Access Compliance Report

Public Rights-of-Way

(Curb Ramps)

Intersection ID: 12504	Main Street: N_BREVARD_ST	Cross Street: E_5TH_ST	Location: E
ADA ID: 79026F419F52	Ramp Type: Directional1	Initial Pass/Fail: Pass	Overall Compliance: No
		Severity Score: 0.25

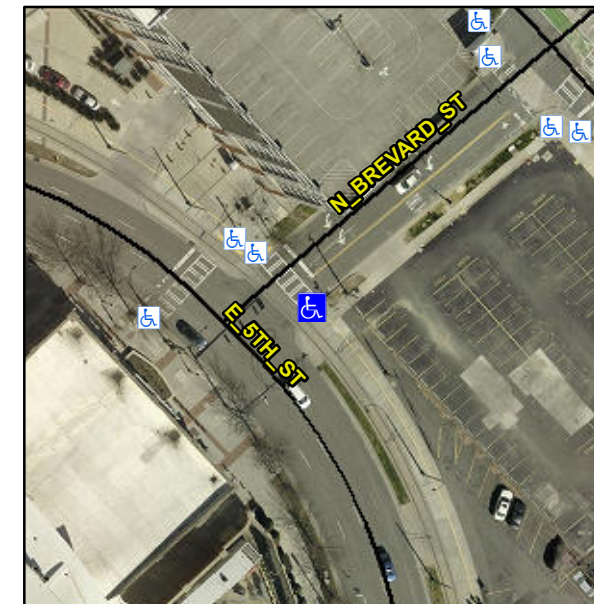
Remove & Replace Entire Ramp.

R304.5.3
